Proposed text based on TCI

G. ZIMMERMAN, CME CONSULTING

5/2/2023

TCI/MDI specification

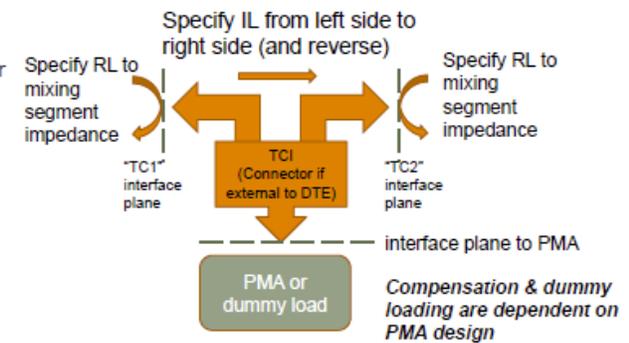
TCI connects to left and right trunk pairs and presents both sides as a 4 pin interface to the PMA (MDI plane)

The TCI meets different RL & IL specs depending on whether PMA/loading is or is not attached

When no PMA attached, the TCI maintains continuity between the left and right sides of the mixing segment as part of mixing segment (like an inliner)

When a PMA is attached, the TCI routes continuity of through 4 signal interface (p_left, n_left, p_right, r_right) to the PMA, PMA completes the path from left to right

Normal RL specs associated with the MDI are met at both the left and right side of the TCI – not at a single MDI interface plane

TCI specification contains the left to right side insertion loss when the PMA is attached

Updated to remove "MDI" language and clarify it is the PMA attached
